LIMITING CONDITIONS FOR OPERATION AND SURVEILLANCE REQUIREMENTS

ADDITIONAL CHANGES PREVIOUSLY
PROPOSED BY LETTER
Serial No. 2612 Date 11/2/99

Docket Number 50-346
License Number NPF-3
Serial Number 2470
Enclosure 2

Figure 3.1-1 Boric Acid Addition System
Minimum Required Volume as
a Function of Boric Acid
Concentration Required in
Modes 1-4

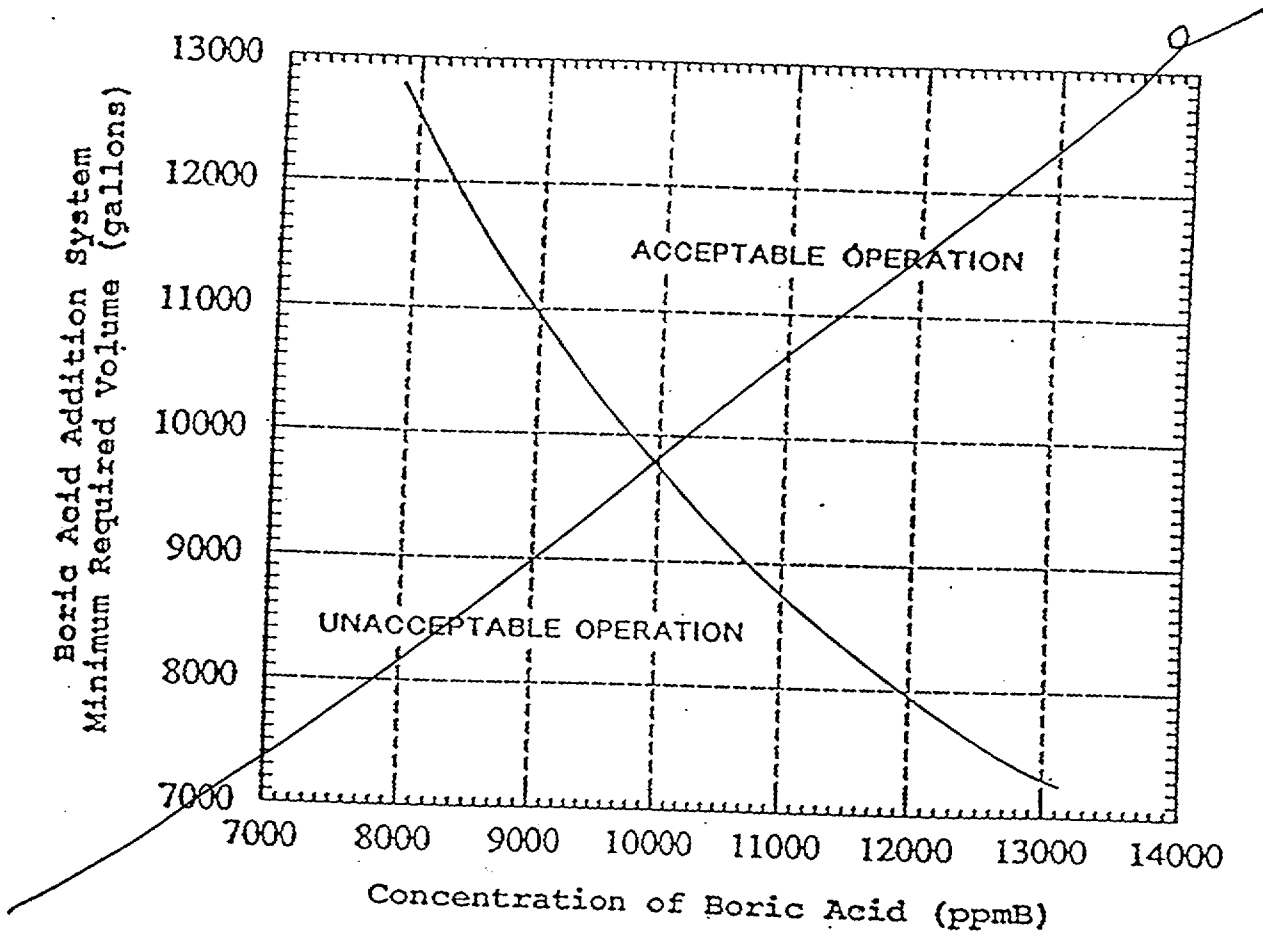
DELETED

Relocate the requirements of TS 3/4.1.2.8 and 3/4.1.2.9 to the TRM.
